TE1163-TE-00-XX-GE-LT-011-V01

**TIER RESPONSE TO ENVIRONMENT AGENCY RESPONSE DATED 21st SEPTEMBER 2023 –
23/01949/REM**

This letter has been prepared to further assess the results of soil leachate data obtained from beneath the Unit 02 area of the proposed development at the Symmetry Park Merseyside site located off Fox's Bank Lane, Cronton, L35 3SU.

Figure 1 Location of Leachate Samples

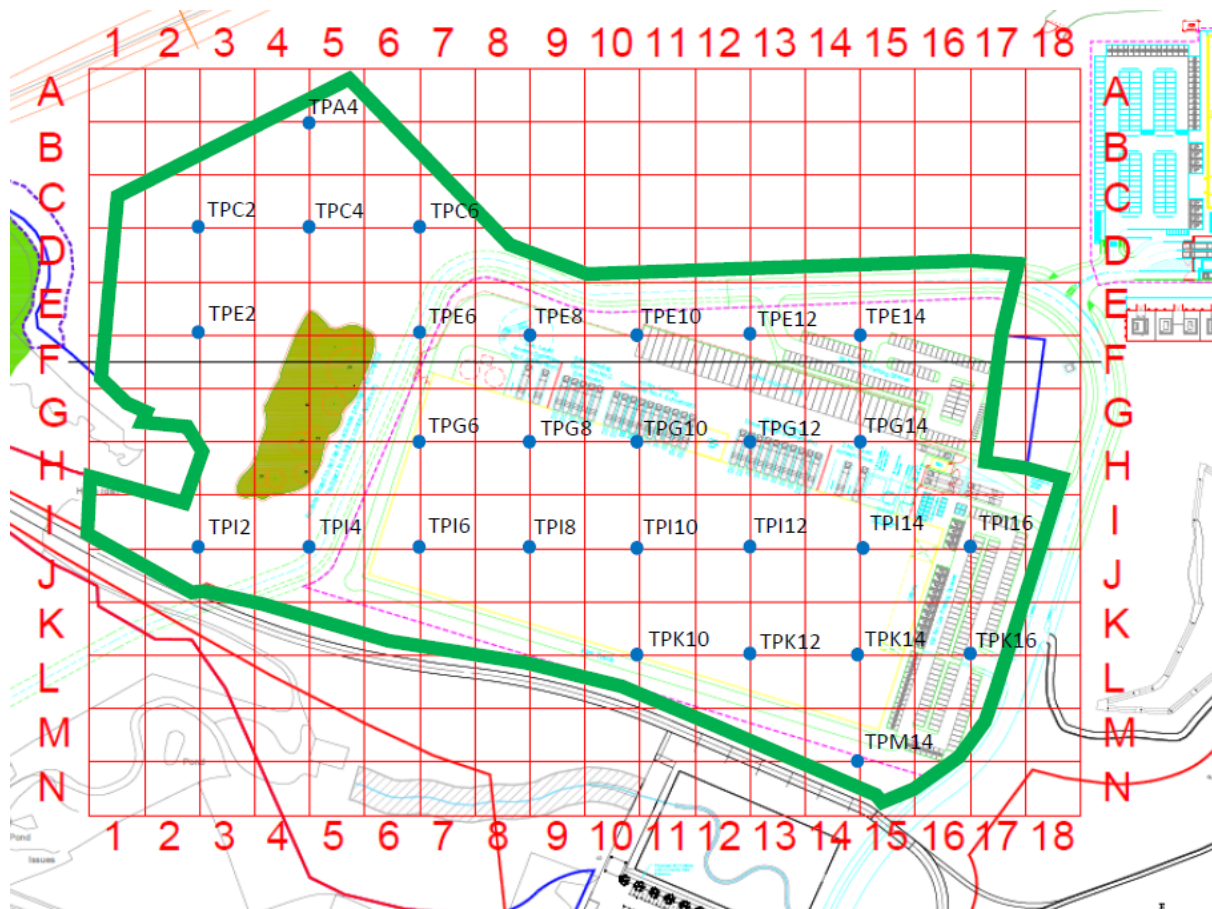
We do not agree with the conclusions that are presented in the report, based upon the data provided and our knowledge of the site history there is a credible pollutant linkage from this area of the site (Unit 2) to controlled waters receptors.

In this case our concerns are particularly around the soils and their ability to create a leachate that may impact the watercourse to the south. We have particular concerns around the possibility of high Iron and manganese levels from the colliary spoil that we know has been placed in this area. The area around the proposed unit is believed to be the location of a groundwater regs authorisation and a large mass of spoil we know was deposited there in the area. Groundwater concentrations in CP102, CP107 and CP108 have shown very high concentrations which would be associated with ochre in these areas, whilst CP102 is in this area it likely represents a deeper groundwater body CP107 and CP108 are not located in the area in question. Leachability analysis of contaminants of concern for colliary spoil does not appear to have been completed on any of the soils in this area, which we would have expected given the site history and context.

Further intrusive work is required in order to better characterise the soils and a remediation strategy will likely be required in order to mitigate the risks from the leachate especially considering that building on the site may further compress the soils and expel a slug of leachate.

Tier Environmental conducted additional intrusive investigations in order to assess whether there is a potentially unacceptable risk of pollution of controlled waters. Samples of soil leachate have been submitted for laboratory chemical analysis from the locations shown below:

Analytical data from the soil leachate sample testing undertaken by Tier Environmental have been evaluated against Water Quality Standard (WQS) values appropriate to the Conceptual Site Model in a manner consistent with that described in the Ground Investigation Report previously produced by Tier Environmental (report reference: TE1163GIR1.3, dated 1st December 2021). The laboratory chemical analysis data is presented in Appendix B.

TEMPORARY SURFACE
WATER MANAGEMENT
SCHEMATIC

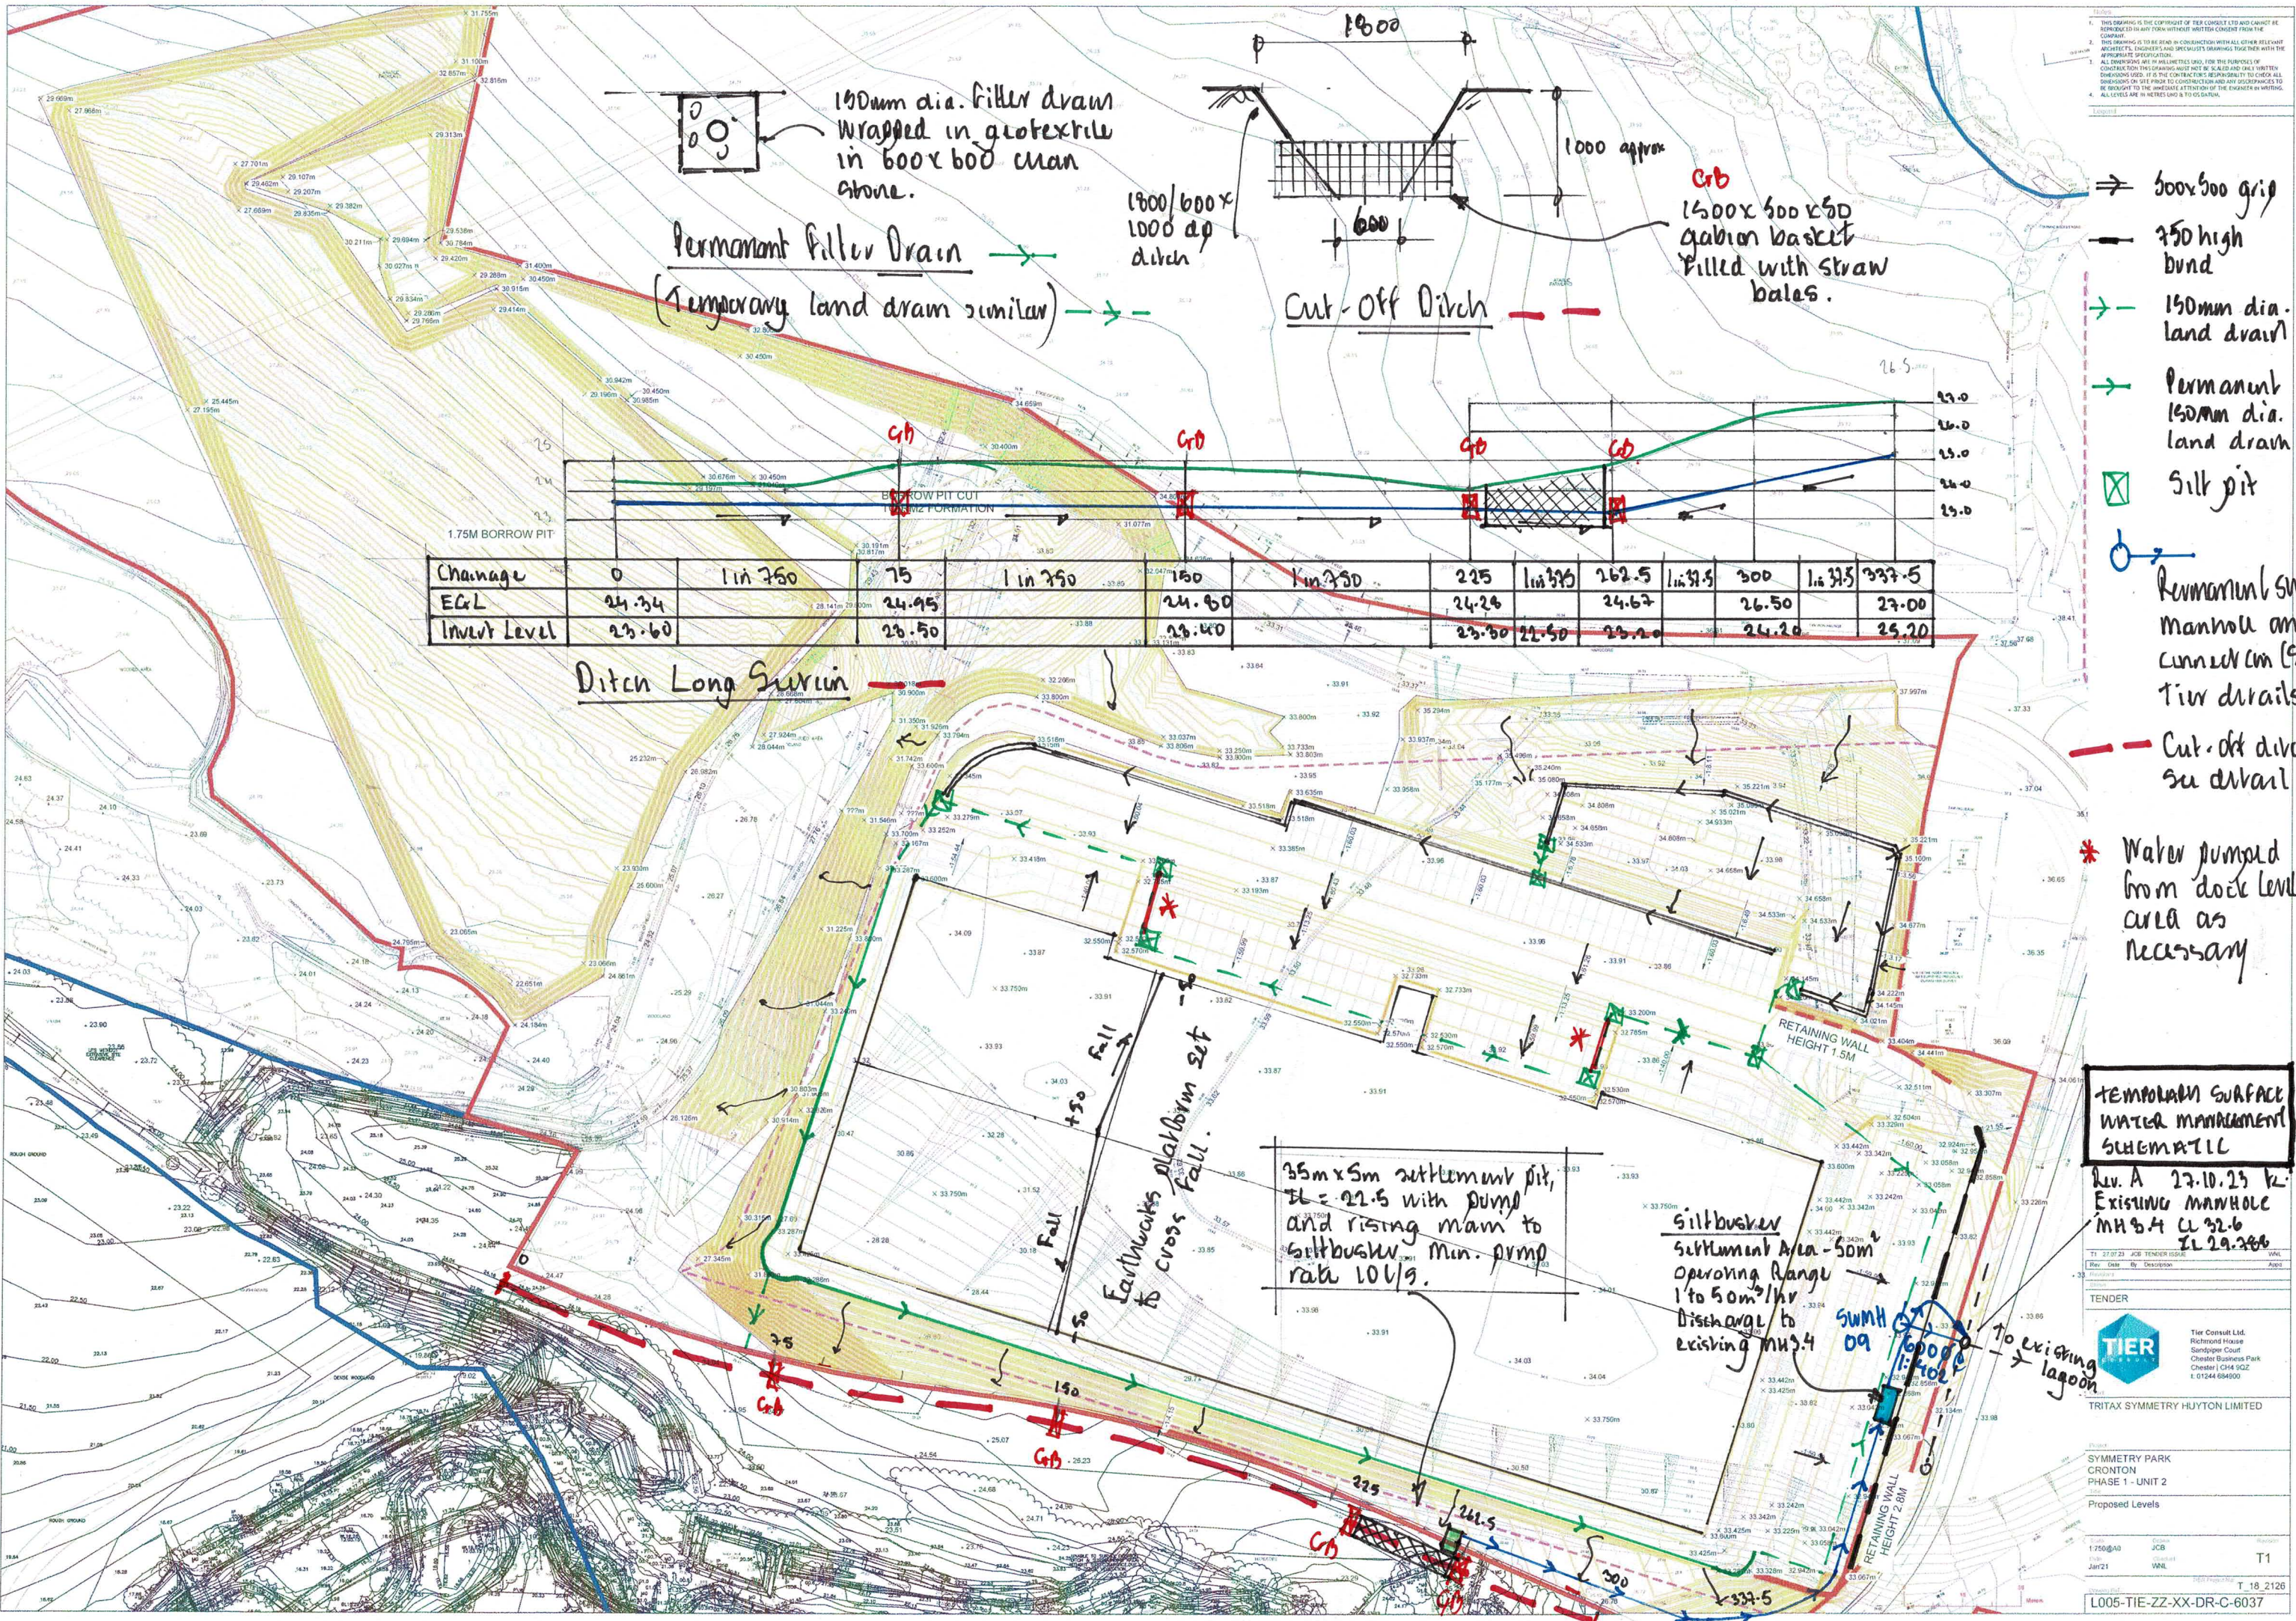
Tier Environmental understand that the Environment Agency have primary concerns associated with the short-term risks associated with the earthworks, but also longer-term risks associated with any leaching driven by a future unforeseen drainage / water pipe leakage.

- A surface water management plan has been produced for the site and is presented within Appendix A. In summary this comprises land drains surrounding the Unit 2 application area to capture any surface water runoff. These waters will then enter a purpose-built settlement lagoon and run through a siltbuster. They will then be pumped up to a higher elevation on the eastern extent of Unit 02. To be deposited into the wider drainage that drains into the eastern country park attenuation ponds.
- All fresh surfaces will be “sealed” via proof rolling to reduce permeability at the surface.
- The slope to the south of Unit 02 will be re-engineered to enhance the inherent low permeability properties of the colliery spoils detailed above even further.
- Tier will be undertaking a watching brief throughout the earthworks.
